APPEAL SUMMARY

Status: Booloidi Horidoroa			
Appeal ID: 14945	Project Address: 375 NE Holladay St		
Hearing Date: 4/12/17	Appellant Name: Terrance A. Gruenhagen		
Case No.: B-008	Appellant Phone: 612-373-4656		
Appeal Type: Building	Plans Examiner/Inspector: Jody Orrison		
Project Type: commercial	Stories: 14 Occupancy: R-1, A-3, A-2, B Construction Type: I-A		
Building/Business Name:	Fire Sprinklers: Yes - fully sprinklered		
Appeal Involves: Erection of a new structure	LUR or Permit Application No.: 16-279653-STR-01-MG		
Plan Submitted Option: mail [File 1] [File 2]	Proposed use: commercial - hotel with even & meeting space

Hyatt Regency Portland

ARCHITECTURAL CODE SUMMARY

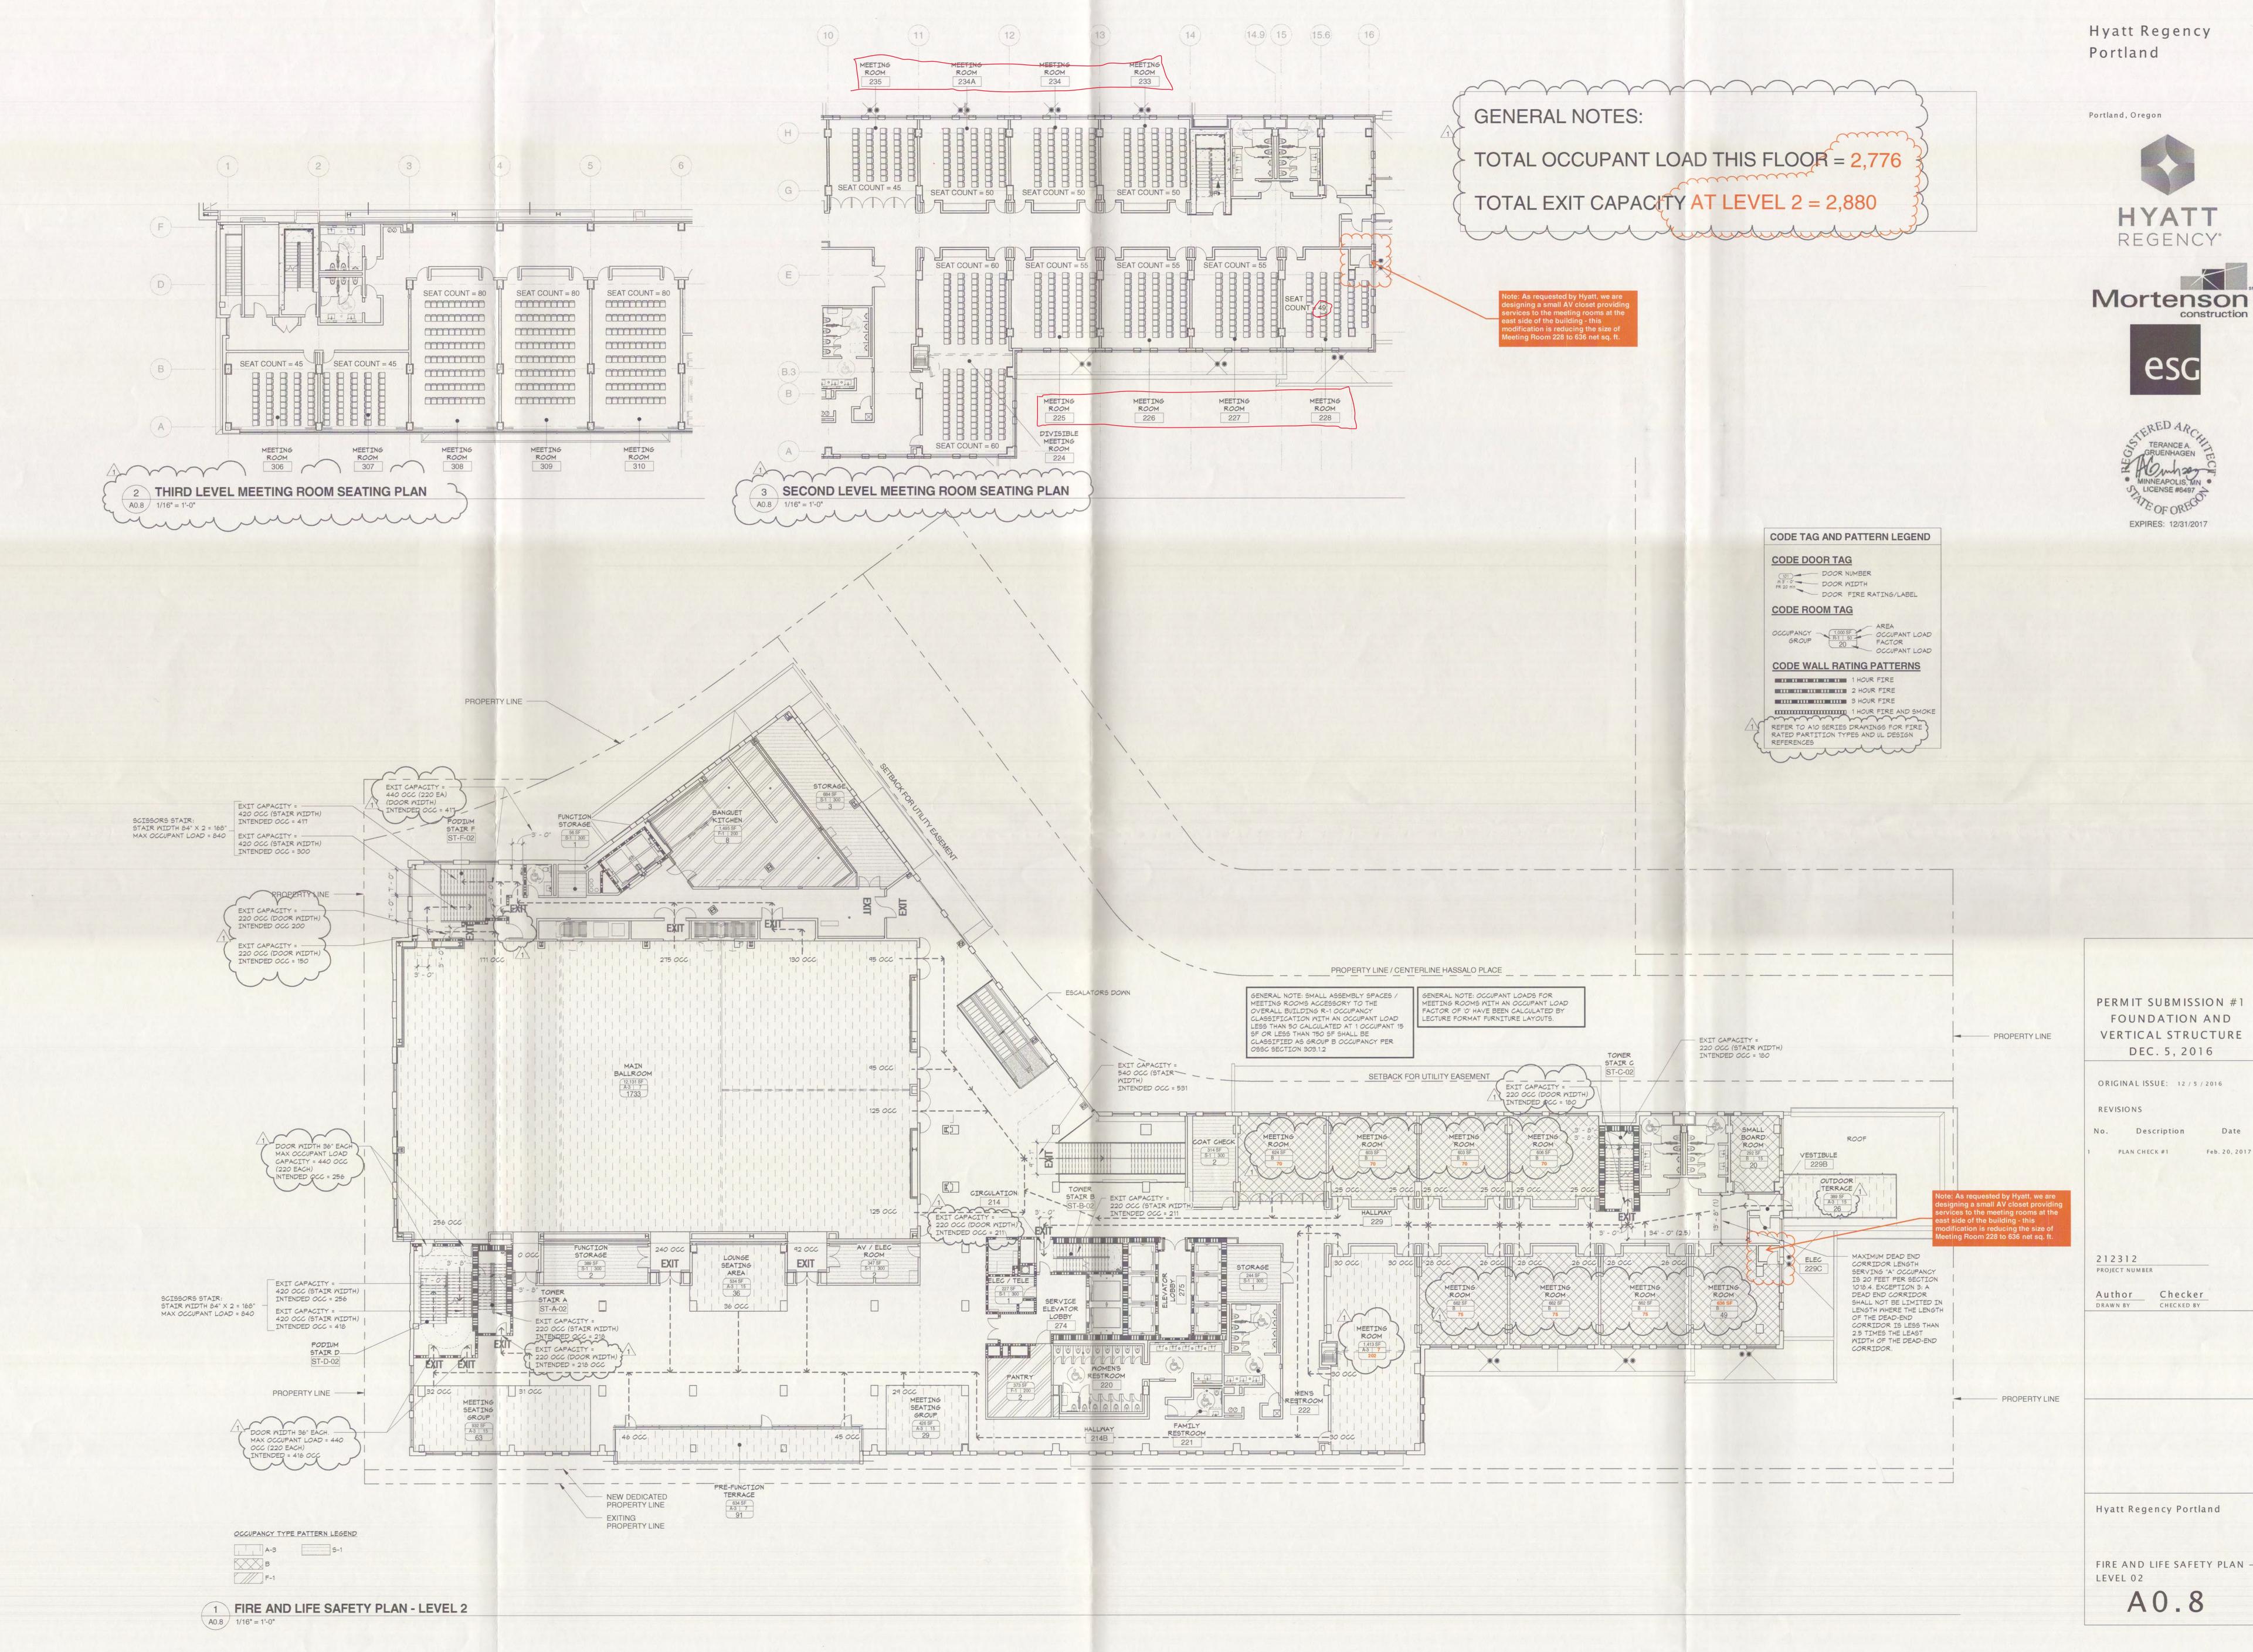
Appeal item 1	eal item 1				
Code Section	Section 1004.1.2 Design occupant load, Chapter 10 - means of egress				
Requires	In reference to the 2014 Oregon Structural Specialty Code - Chapter 10 Means of Egress Section 1004.1.2 Design Occupant Load - Areas without fixed seating - Exception				
Proposed Design	On floor level 2 of the hotel, the design team requests approval by the Building Code Official to utilize an occupant load slightly less than the tabular load of 7 sf per occupant for a concentrated use assembly space without fixed seats for the following meeting rooms (by Room Number on the Floor Plan):				
	Meeting Room 225 - Net Floor Area = 662 sf Proposed Max. Occupancy - 75 Ref. Net Area/Occ. = 8.8 sf Meeting Room 226 - Net Floor Area = 662 sf Proposed Max. Occupancy - 75 Ref. Net Area/Occ. = 8.8 sf Meeting Room 227 - Net Floor Area = 662 sf Proposed Max. Occupancy - 75 Ref. Net Area/Occ. = 8.8 sf Meeting Room 228 - Net Floor Area = 636 sf Proposed Max. Occupancy - 49 Ref. Net Area/Occ. = 12.9 sf Meeting Room 233 - Net Floor Area = 603 sf Proposed Max. Occupancy - 70 Ref. Net Area/Occ. = 8.6 sf Meeting Room 234 - Net Floor Area = 603 sf Proposed Max. Occupancy - 70 Ref. Net Area/Occ. =

8.6 sf Meeting Room 234A - Net Floor Area = 603 sf Proposed Max. Occupancy - 70 Ref. Net Area/Occ. = 8.6 sf

Meeting Room 235- Net Floor Area = 624 sf Proposed Max. Occupancy - 70 Ref. Net Area/Occ. = 8.9 sf

Reason for alternative On the 2nd floor level of the hotel the intermediate sized Meeting Rooms on the east side are designed to function either with table and chair seating or rows of seats in a seminar or classroom style set-up. Using a "seminar or classroom" style arrangement yields a higher occupant load. Based on actual furniture layout studies as shown for reference on drawing A0.8 enclosed, most of the Meeting Rooms sized at between 600 and 675 sf have an actual seating capacity between 50 and 60 occupants (i.e. using an actual number of occupants approach).

> We request the Building Code Official formally approve a maximum occupant load based on actual number for each of these intermediate meeting rooms as listed above. This is allowable pending approval per the Exception under 1004.1.2.

Maximum occupant loads to be based on furniture layout for multipurpose assembly rooms: Granted as proposed for the rooms indicated. Final furniture layouts to be approved by the fire marshall's office.
